Chapter 10

Comments and Responses on the Draft EIS

The Energy Facility Site Evaluation Council (EFSEC) sought comments on the Draft Environmental Impact Statement (EIS) from members of the public, regulatory agencies, tribes, and other stakeholders. The Draft EIS was made available for review and comment to all interested parties and was posted to the publicly accessible EFSEC website: http://www.efsec.wa.gov/Tesoro%20Savage/SEPA%20-%20DEIS/DEIS_PAGE.shtml. The official comment period for the Draft EIS was 60 days: from November 24, 2015, through January 22, 2016. The public was invited to review and comment on the Draft EIS through a dedicated comment website, by email or mail, or at a public meeting in which comments could be provided in either written or oral format. All comments received on the Draft EIS, whether in written or verbal form, were considered by EFSEC in preparing this Final EIS.

Figure 10-2 US National Mainline Freight Accidents, 1975–2015

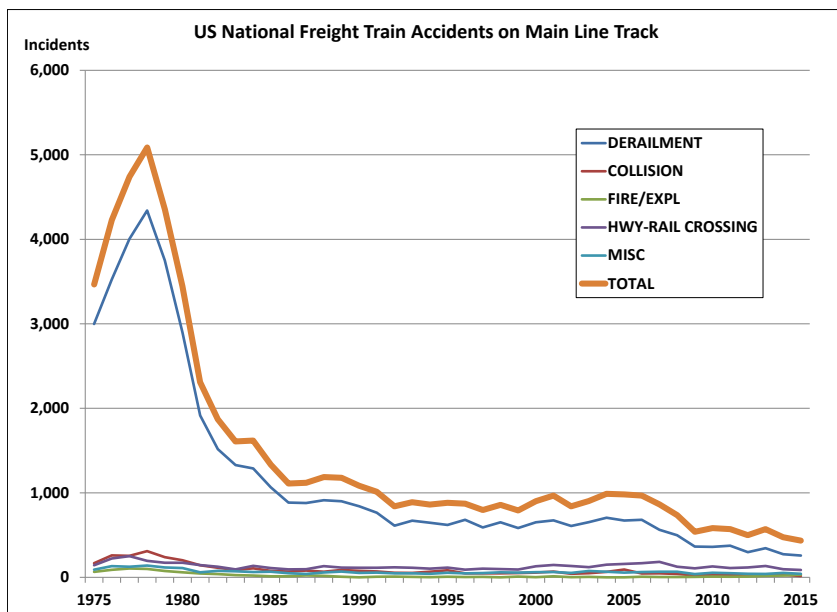
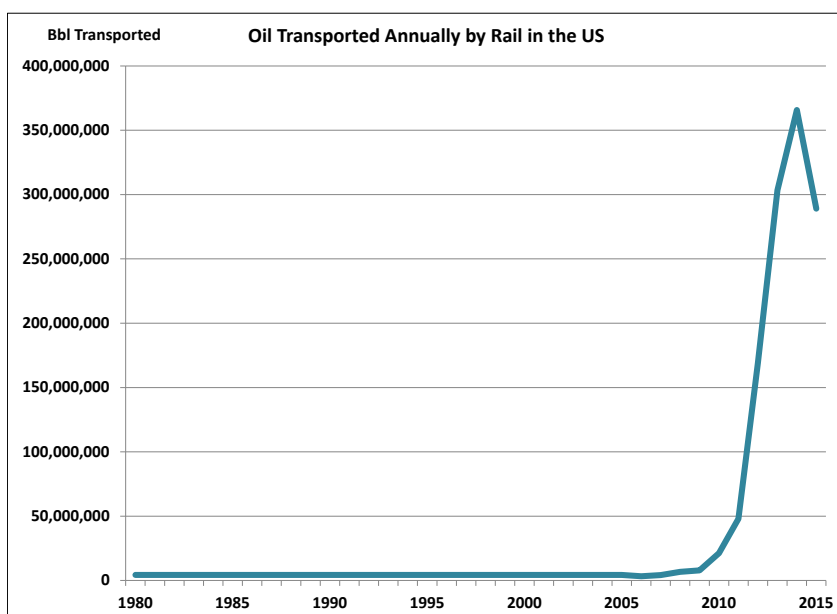
- Reassess the probability of derailments considering accident data specific to crude oil unit trains rather than historical accident data for all types of freight cars. Alternatively, reassess the probability of derailments and oil spills for train traffic using various data sources including BNSF non-yard derailment rates; FRA or NTSB data on the total number of tank car punctures or ruptures since 2012; the number of tank car derailment spills in North America since the beginning of 2013; the number of tank cars carrying alcohol, propane, LPG, diluted bitumen, and other crude; the number of loaded tank cars that have ruptured or caught fire in an accident since 2012; and Canadian rail incidents.

- Calculate the likelihood of incidents considering specific crude oil railcar types (e.g., US Department of Transportation [DOT]-117 vs DOT-111 railcars).

that most strongly influence accident frequencies and locations (Appendix E). Some commenters expressed concern that using data for all freight rail would downplay the risk of a derailment from the Proposed Action; however, using historical data for all freight rail dating back to 1975 actually incorporates higher accident frequencies. As shown on Figures 10-2 and 10-3, the frequency of freight train accidents decreased dramatically in the late 1970s and early 1980s as several important rail operations and equipment safety regulations were enacted, and crude oil transport by rail has only significantly increased within the last 5 years (Appendix E).
